**PRELIMINARY DRAINAGE REPORT  
FOR  
ESTATES AT CATHEDRAL PINES,  
EL PASO COUNTY, COLORADO**

PCD File No. ~~SF22-XXX~~  
PUDSP2210

September 2022

**Preliminary Drainage Report for Estates at Cathedral Pines**

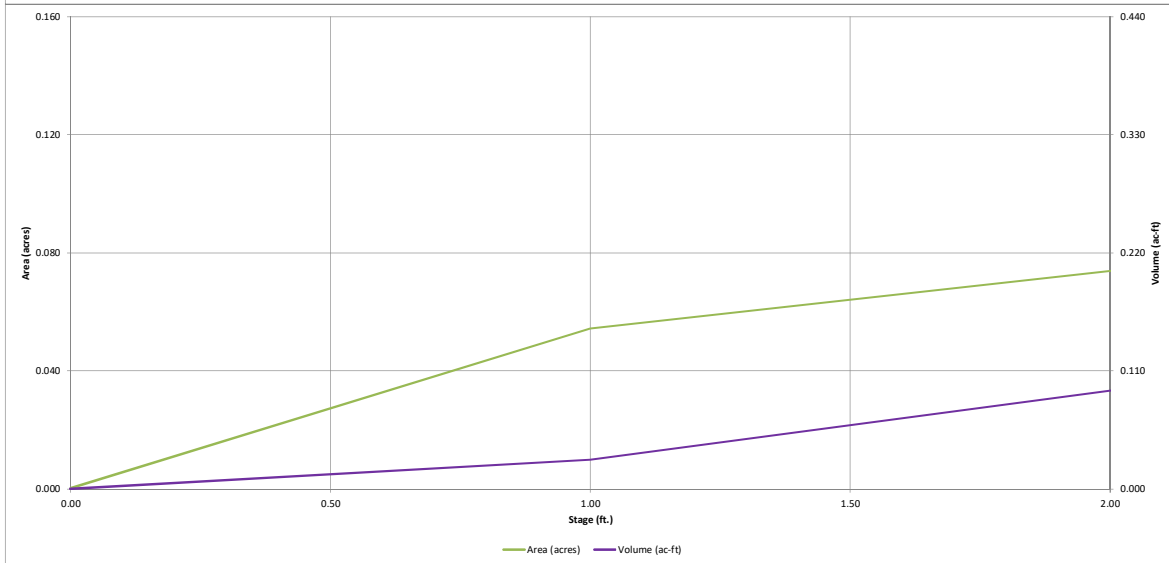
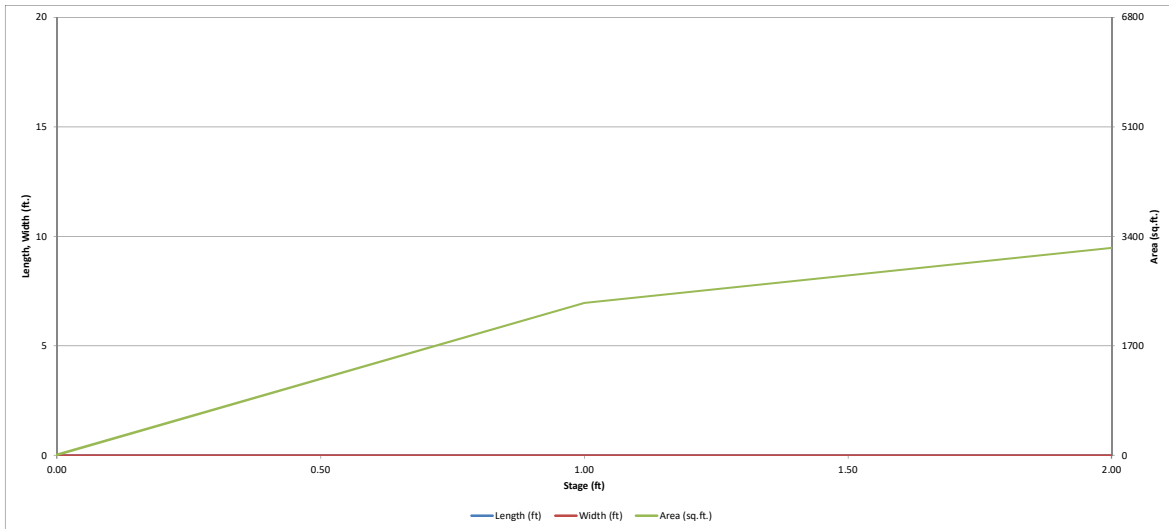
Pond worksheet will be reviewed further once pond details are provided.

Please provide forebay design calculations (MHFD-BMP spreadsheet). The minimum forebay volumes are shown on MHFD T-5 Table EDB-4. The forebay outlet should be sized to release 2% of the undetained peak 100-year discharge.

EXISTING DRAINAGE MAP  
CATHEDRAL PINES  
JOB NO. 25260.00  
09/19/2022  
SHEET 1 OF 1

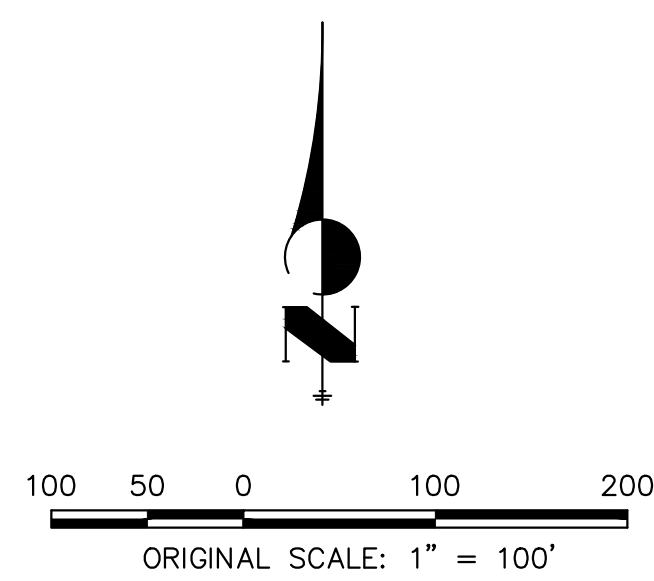
Provide a narrative description regarding the condition of the outfall and recommendation. Is there erosion occurring and will it require additional erosion protection.

PROPOSED DRAINAGE MAP  
ESTATES AT CATHEDRAL PINES  
JOB NO. 25260.00  
9/21/2022  
SHEET 1 OF 1

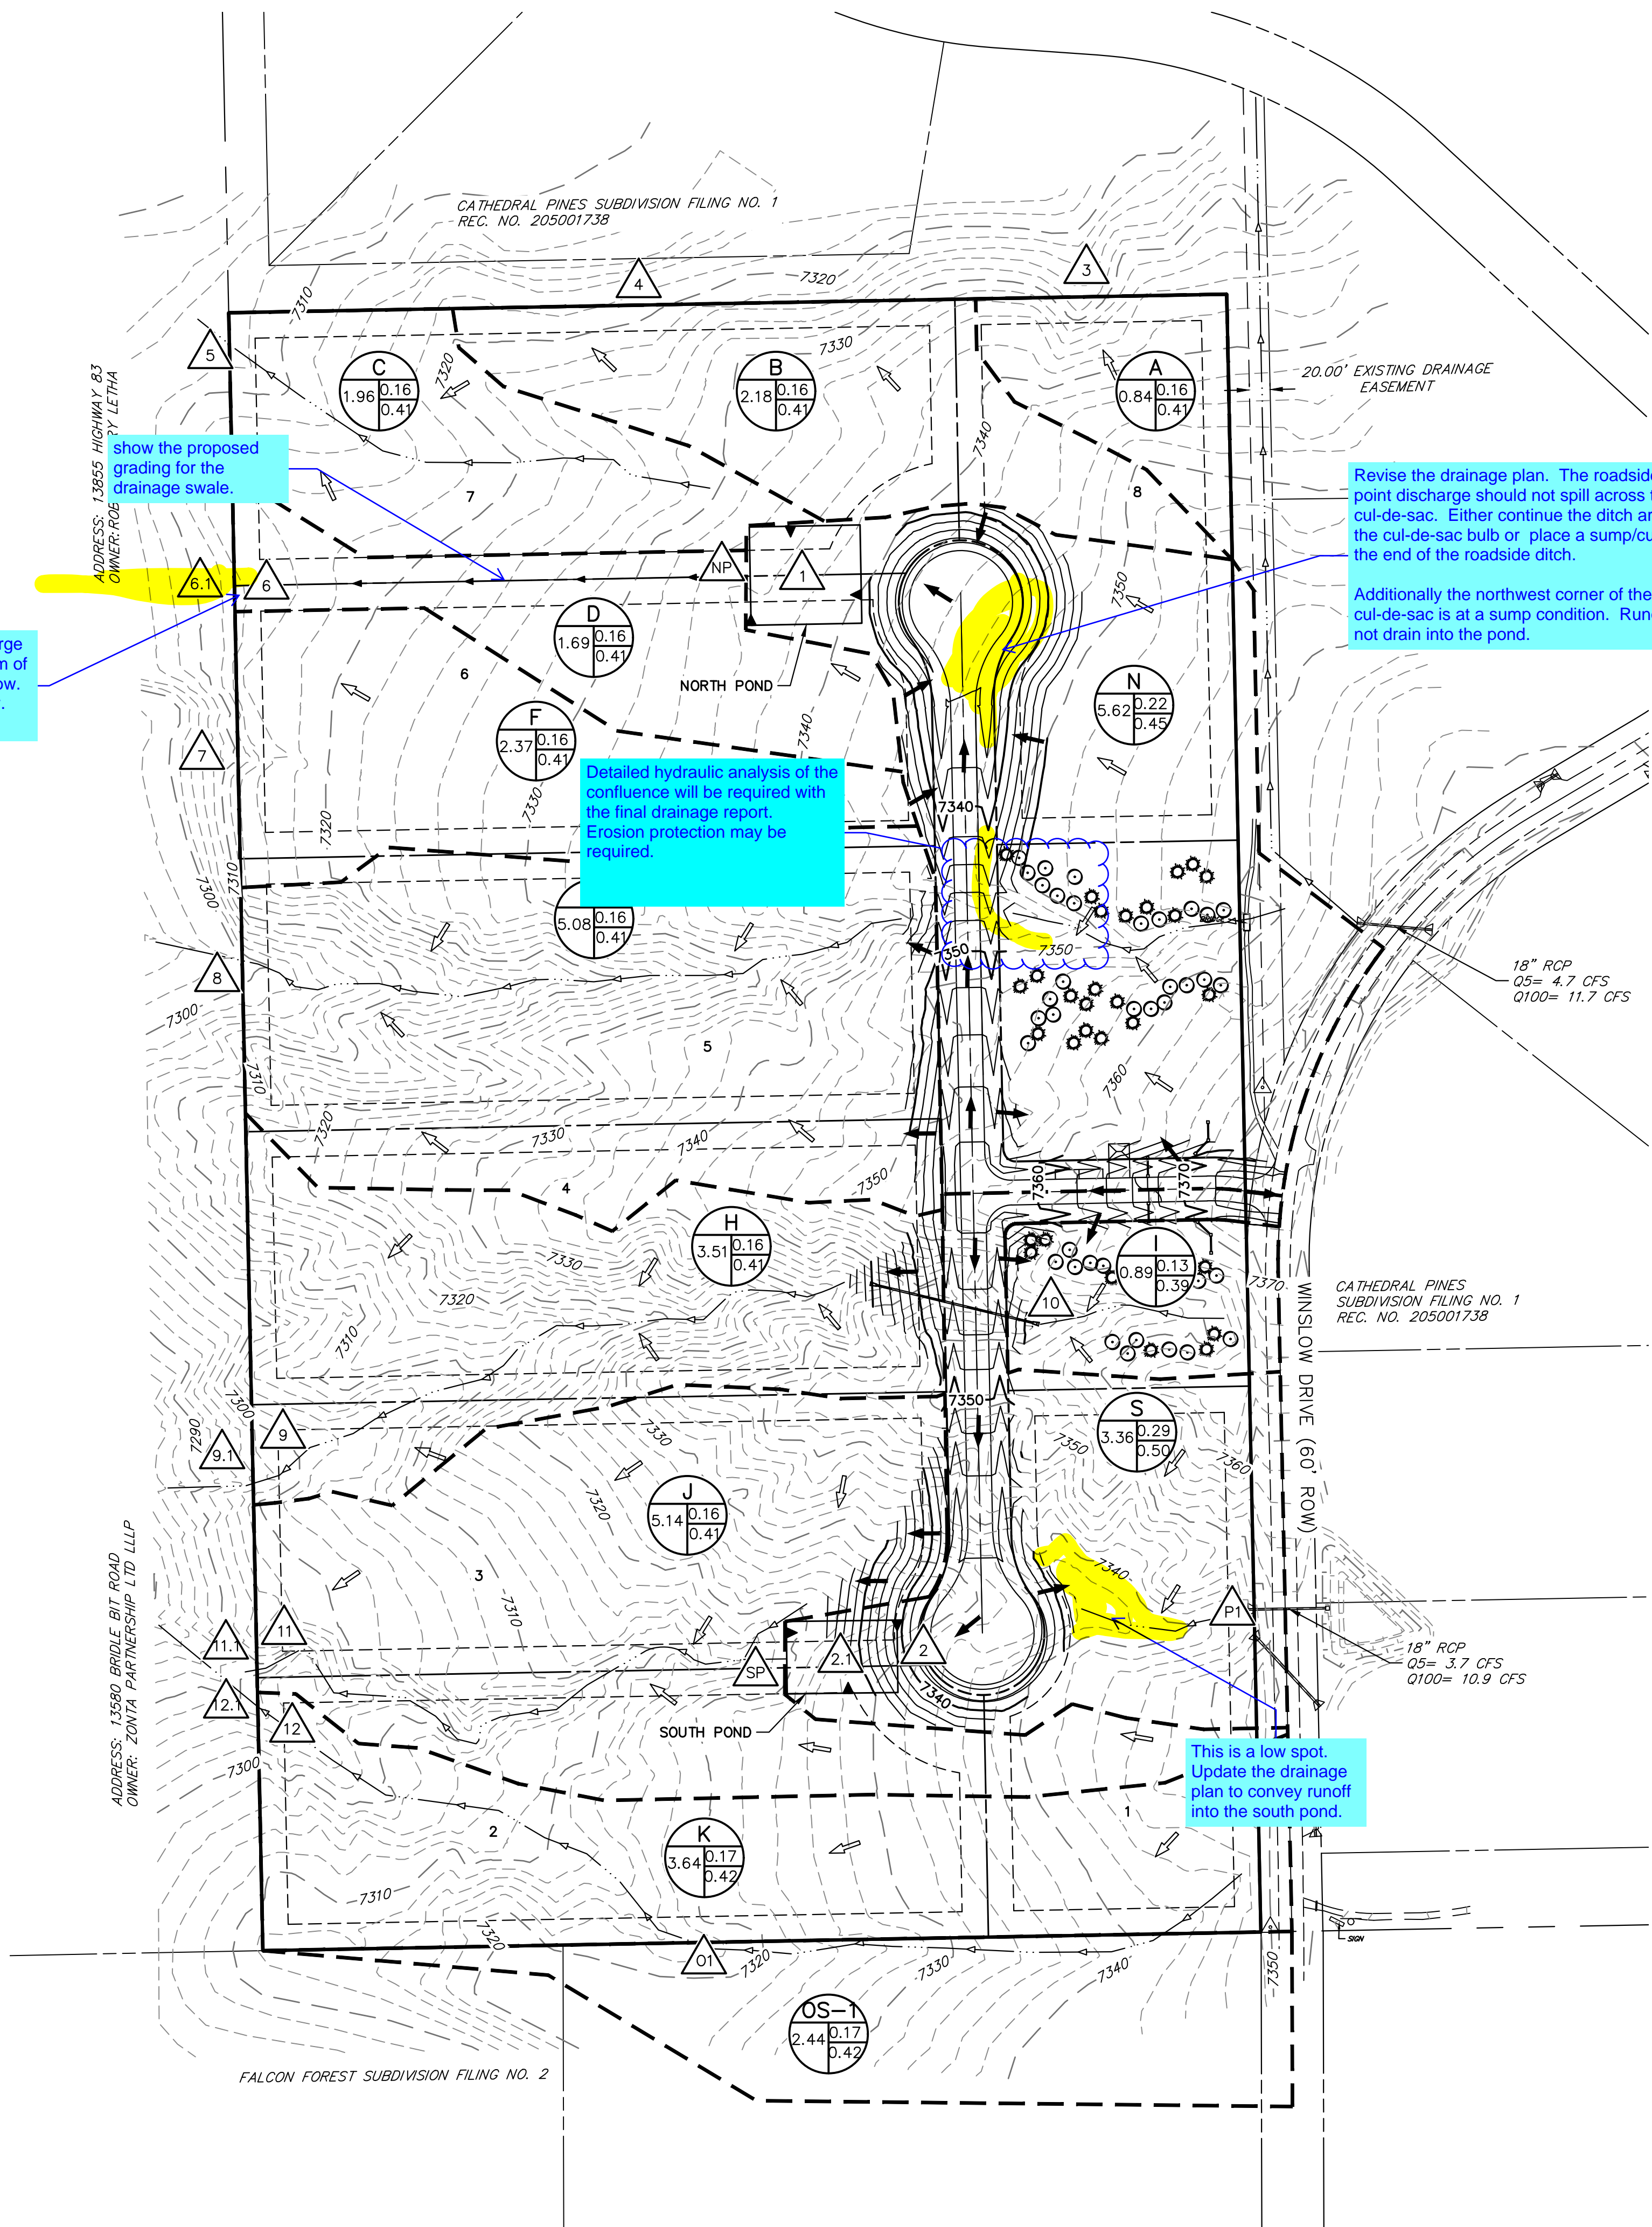
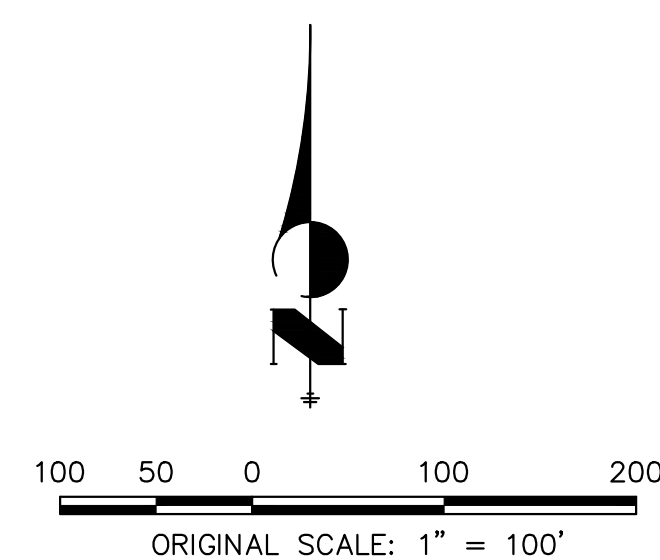
Update the drainage plan. The highlighted DP (3, 7, 9.1, 11.1, 12.1) release rates in the developed condition shall not exceed the historic runoff rate.
